Dewberry's Response to USGS' Review

Northern Counties Acquisition and Classification for FEMA VA LiDAR

**USGS Contract:
G11PD00089**

Report Date: March 27, 2012

Figure 1 – Before/After image of DEM_N26_0618_30 and DEM_N26_0619_40 showing that the data gap is addressed in the new delivery (image on the right).

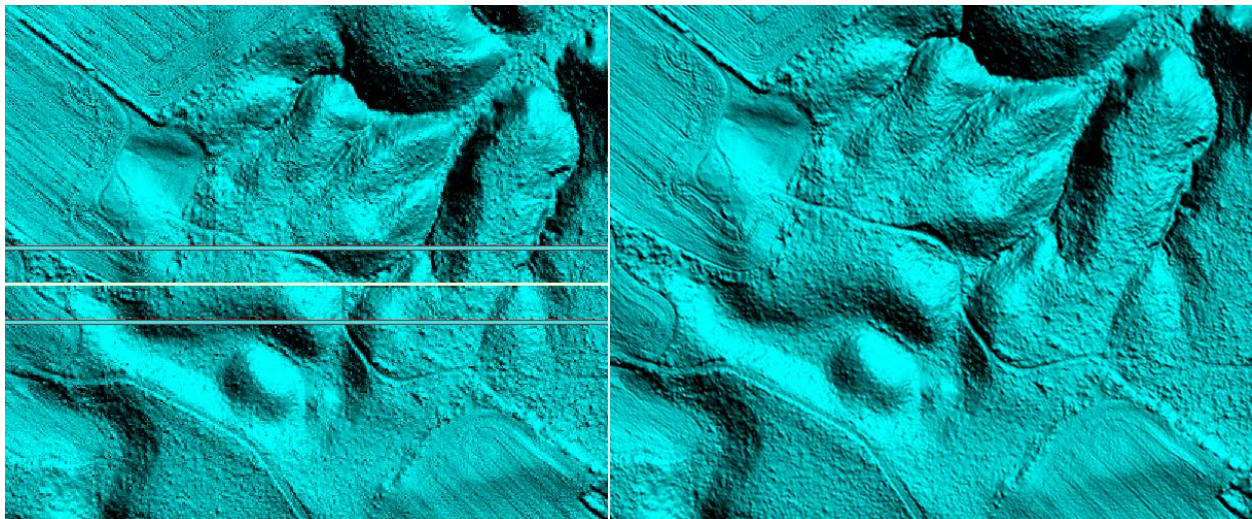
The USGS called out a linear feature where no data appeared in the DEMs. The gap was ~10 feet in width, ran east to west, and occurred between the seams of tiles. Dewberry reprocessed the 31 DEMs and this issue no longer exists. Figure 1 shows an example of new DEMs with no pixel gap.

Figure 2 - Image provided by USGS of digital elevation model of tile DEM_N16_8932_40.

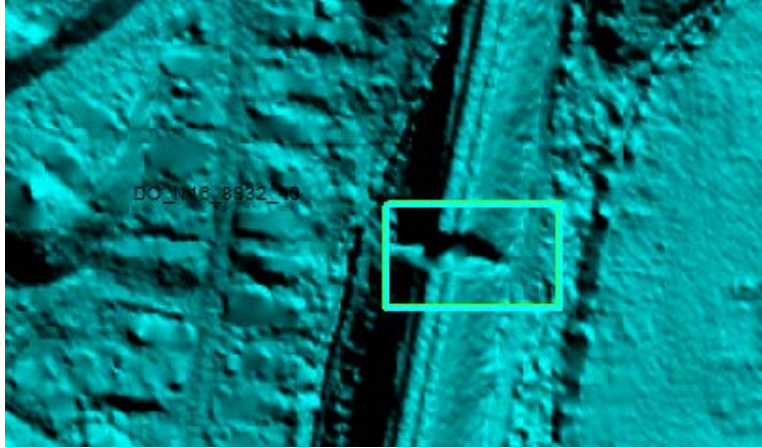
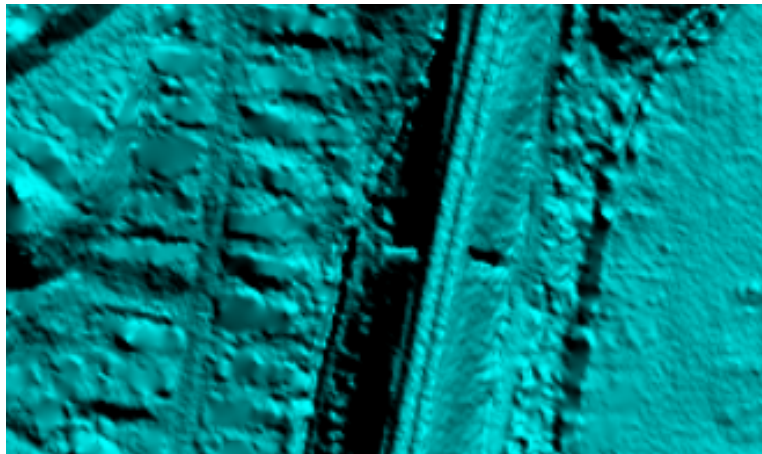
The USGS identified 4 culverts that were removed from the ground model because they were assumed to be bridges. These culverts were added back to the ground model in the LAS tiles and the DEMs were reprocessed to reflect these changes. Figure 2 to Figure 5 show two examples of how the culverts were added back to the ground model.

Figure 4 - New digital elevation model of DEM_N16_8932_40 showing the culvert is added back to the ground.

Figure 6 – Before/After of tile DEM_N16_7967_10 showing that the lake feature is now hydro-flattened in the DEM. The breakline features are added to the breakline GDB.

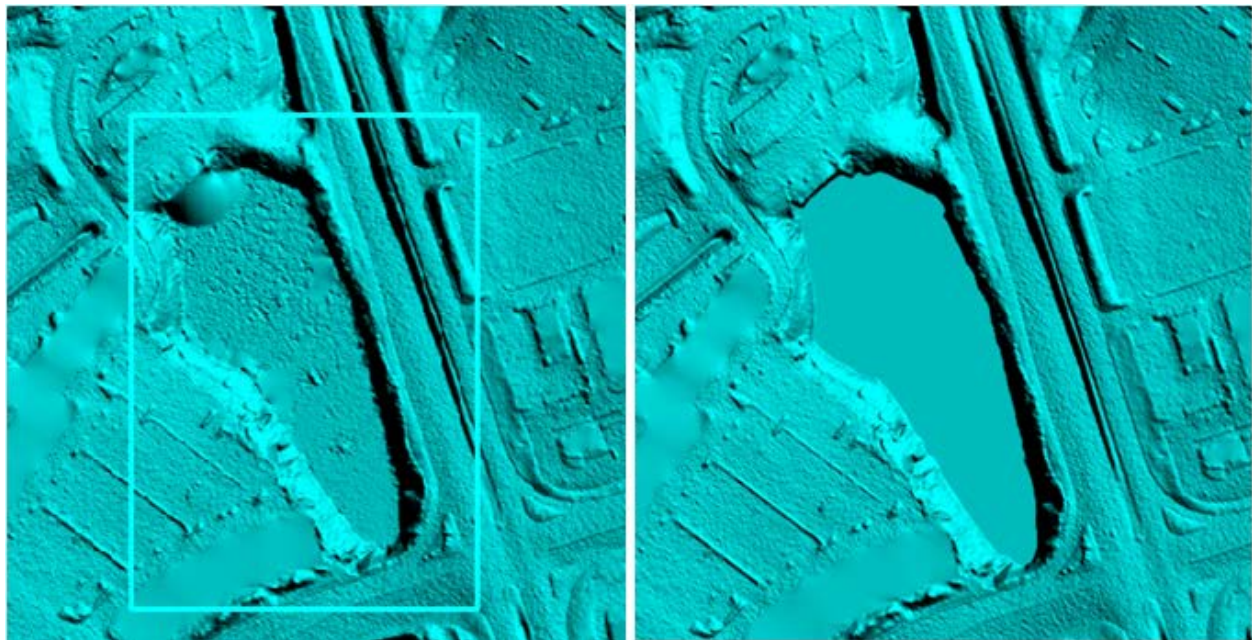
The USGS called out 3 issues with the breaklines. One of these issues was a lake that was not collected in the initial delivery. The lake feature was added to the breaklines in the 2nd delivery and the LAS and DEM was reprocessed to address the change (Figure 6). An additional issue was an edit to the tidal waters breaklines where additional coastline was added to the breaklines. The change to the tidal waters breaklines was addressed in both the LAS and DEM (Figure 7 and Figure 8). The last change was a monotonicity issue where a river drops several feet in elevation over a short length. The area was reprocessed and manually edited to force the stream to flow monotonically (Figure 9 and Figure 10).

Figure 11 - Image provided by USGS of digital elevation model of tiles DEM_N26_0618_30 and DEM_N26_0619_40. The red line is the new project boundary and the black line is the old project boundary. The new line incorporates the island into the ground model.

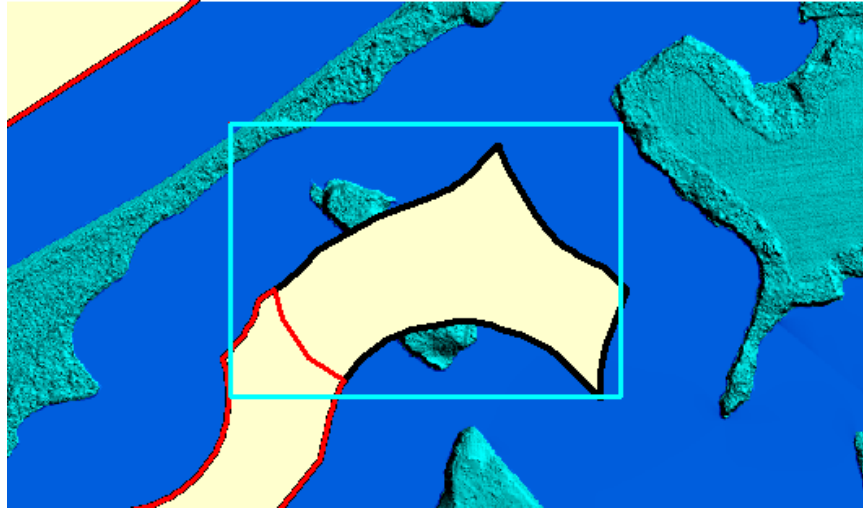
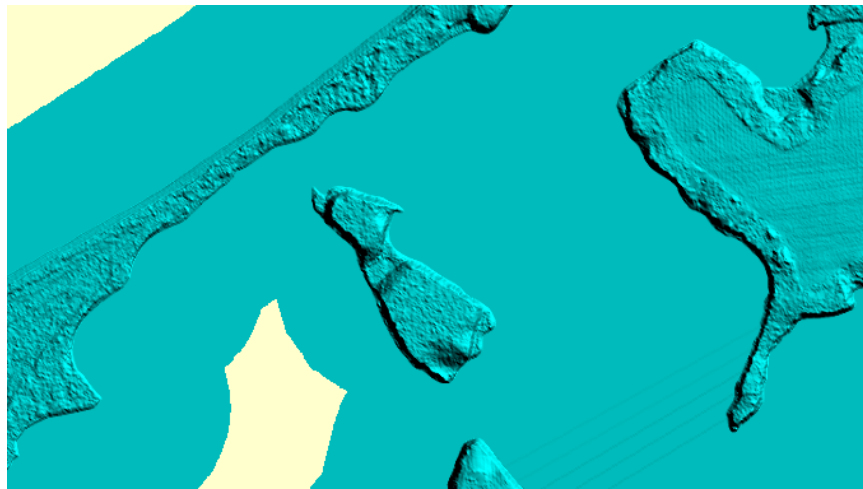
The USGS called out 6 areas of data voids. Upon review, it was determined that these areas fall outside the project boundary and, with the exception of one call, occur in water. Therefore, no edits were made to the majority of the calls. One change was made to the project boundary to add an island to the

ground model. The LAS, breaklines, and DEMs were all reprocessed to reflect this addition (Figure 11 and Figure 12).

Figure 12 – Digital elevation model of tiles DEM_N26_0618_30 and DEM_N26_0619_40 showing the island is incorporated into the ground model in the 2nd delivery.

Figure 13 - Before/After of tile DEM_N16_8933_20 showing that the artifact is removed in the 2nd delivery (image to the right).

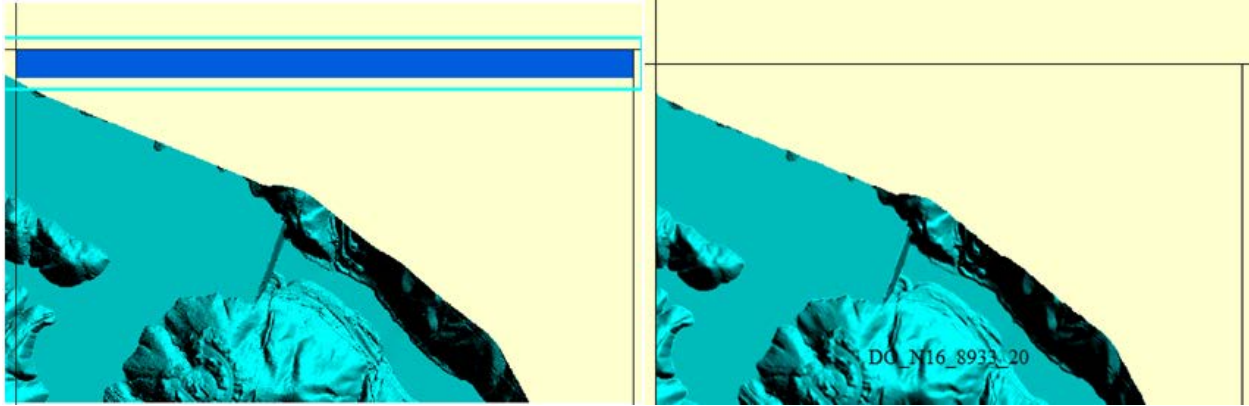
The USGS identified an artifact from clipping a DEM that was left in the original dataset. The DEM was reprocessed and does not exist in the 2nd delivery (Figure 13).

Figure 14 - Image provided by USGS of digital elevation model of tile DEM_N17_7020_30.

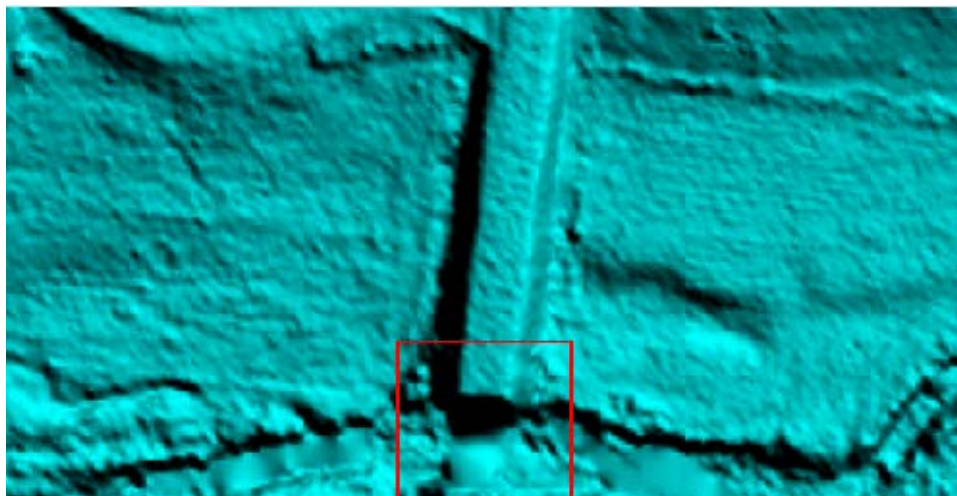
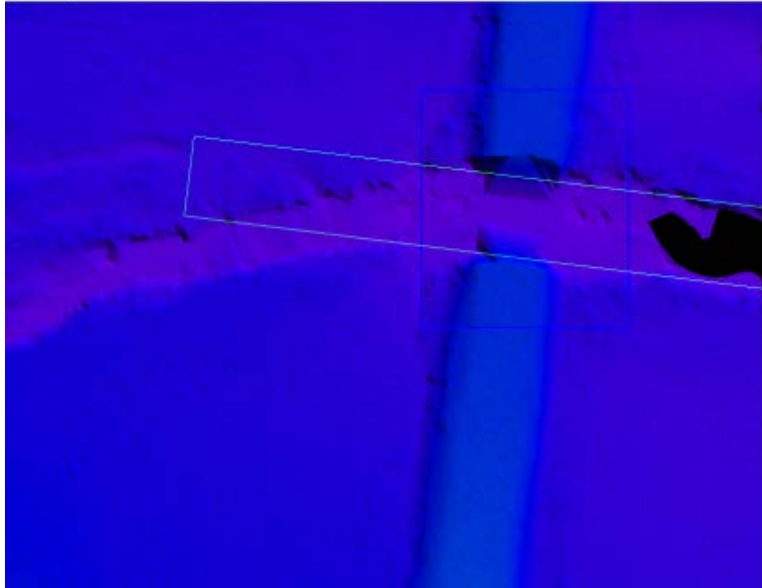
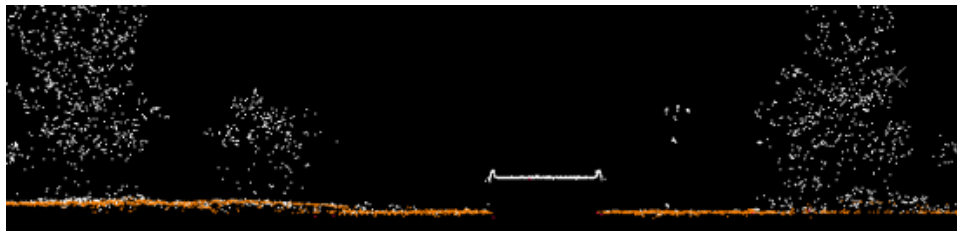
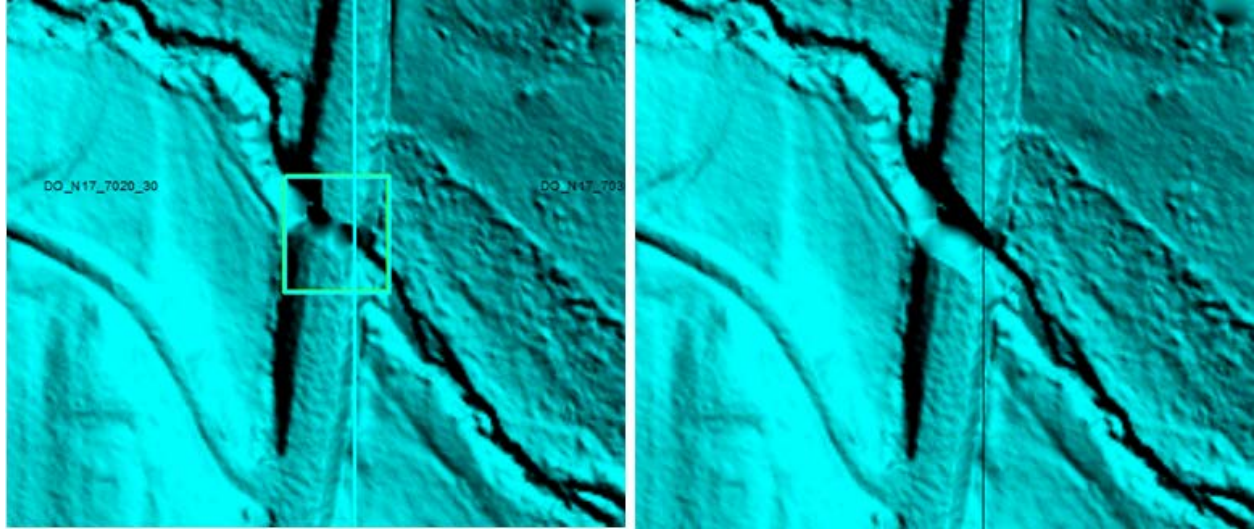
The USGS called out 19 occurrences where the appearance of a bridge was left in the digital elevation model. The DEM surface models are created from Terrains. Terrain models create continuous surfaces from the inputs, in this instance LiDAR ground points and breaklines. Because a continuous surface is being created, the Terrain will interpolate and triangulate across a bridge opening from legitimate ground points on either side of the actual bridge. This makes the model appear to contain a bridge feature when in fact the points on the bridge have been removed from the ground. Therefore, 18 of the 19 edit calls resulted in no change. Figure 1 through Figure 4, below, show examples of how a bridge appears to be left in the surface model due to interpolation, but is in fact removed from the ground surface. Figure 5 below shows the one change to the LAS where a bridge was fully removed from the ground model.

Figure 16 - Profile of LAS from tile LAS_N17_7020_30. The white points are Class 1 (unclassified) and orange points are Class 2 (ground). The bridge is completely removed from the ground points.

Figure 18 – Before/After image of tile DEM_N17_7020_30. The bridge is fully removed in the ground.

Figure 19 – Image to the left is how Global Mapper represents the data and image on the right are the DEMs mosaicked together showing no visible seam exists. The 4 DEMs shown here are DEM_S13_9932_20, DEM_S13_9932_30, DEM_S13_9932_10, and DEM_S13_9932_40.

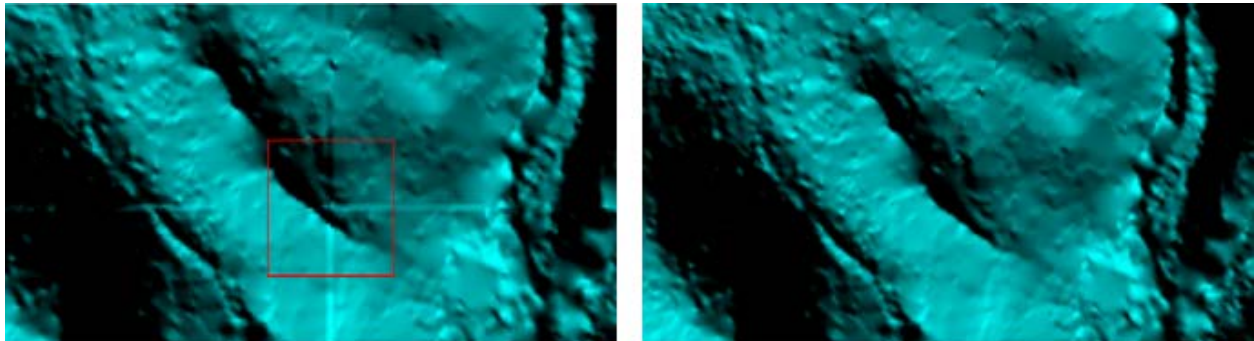
The USGS identified 2 areas where a visible seam appeared between 2 tiles. This seam is a product of the way Global Mapper visually represents the data and is not an artifact that requires fixing in the DEMs. No changes were made to the DEMs. DEMs were mosaicked at these seams to show that no visible difference in elevation or shift in pixels is present in the final data (Figure 19 and Figure 20).

Figure 21 - Digital ground elevation model of tile LAS_N16_7981_10. The larger boxed area was called by the USGS. The smaller box shows the profile of the next image.

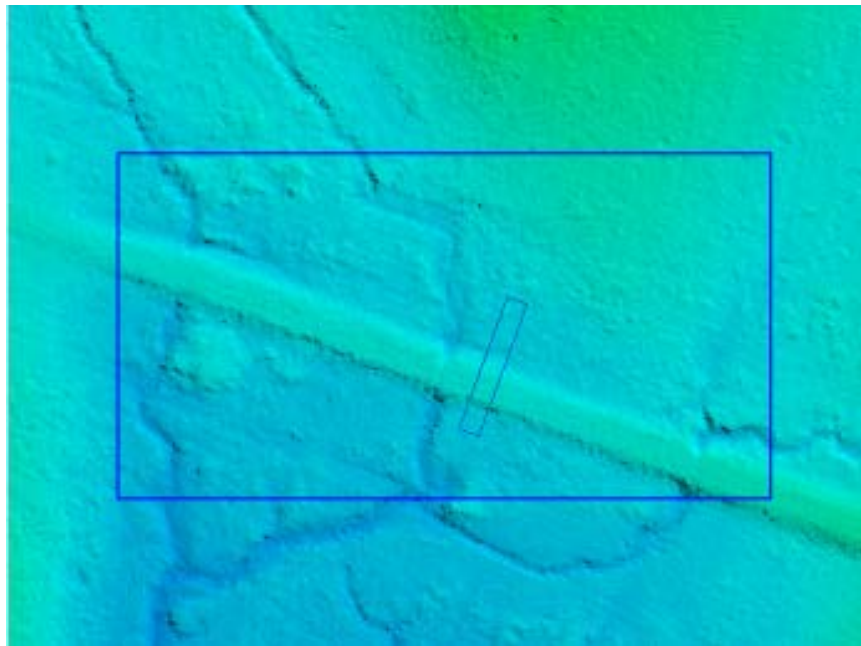
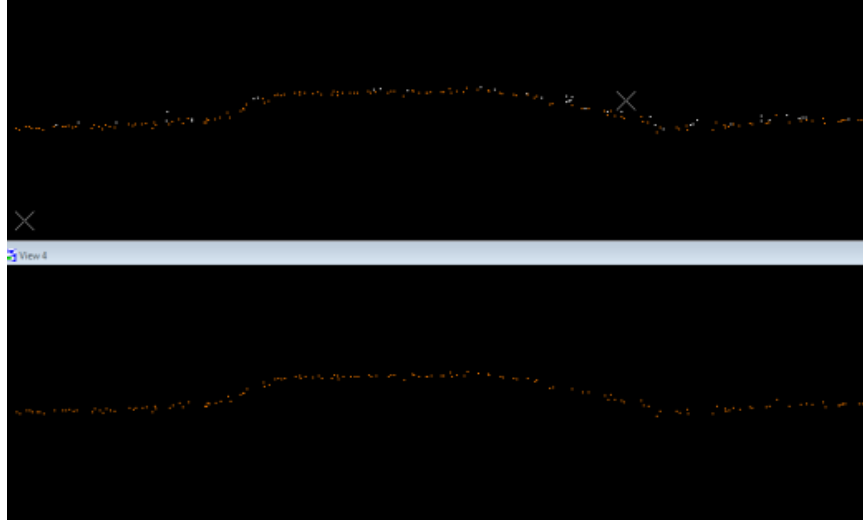
The USGS identified one ground anomaly. This area was investigated and it was determined that the model represents the current ground conditions so no changes were made.

Figure 22 - Profile of LAS from tile LAS_N16_7981_10. The white points are Class 1 (unclassified) and orange points are Class 2 (ground). The ground is accurately depicted in this area.
